Re: King I Mine, C-1981-035 Don May, P.E.: Quarterly Inspection 4th Quarter 2011

## INSPECTION REPORT

Site: National King Coal Mine, GCC Energy , Hesperus, Colorado Inspection Date: 4th Quarter Inspection, Dec 14, 2011 Don R. May, P.E., Project Engineer

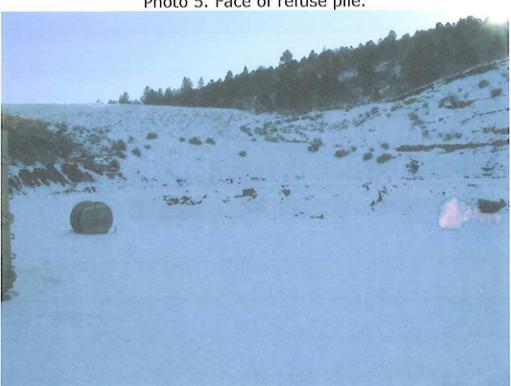
Drainage Ditches: The rock lined "dirty" drainage ditch that carries water from the top of the waste pile is shown in photograph 3. Flow in an area on the left bank, looking downstream, approximately half way down the channel appears to be jumping the channel bank and eroding the adjacent hillside, as mentioned in the previous report. In the spring the channel should be modified to prevent overtopping in this area. Photograph 4 shows one of the inlet-outlet drainage areas in the upper yard. All pipe and drainage grate inlets should be checked and cleared of blockage. In the Sept 2011 inspection one or more drainage grates was covered with debris. Snow cover prevented detailed inspection. These grates should be cleaned in the spring. Care should be taken not to bury drainage grates or ditches with the new fill being placed in the yard area.
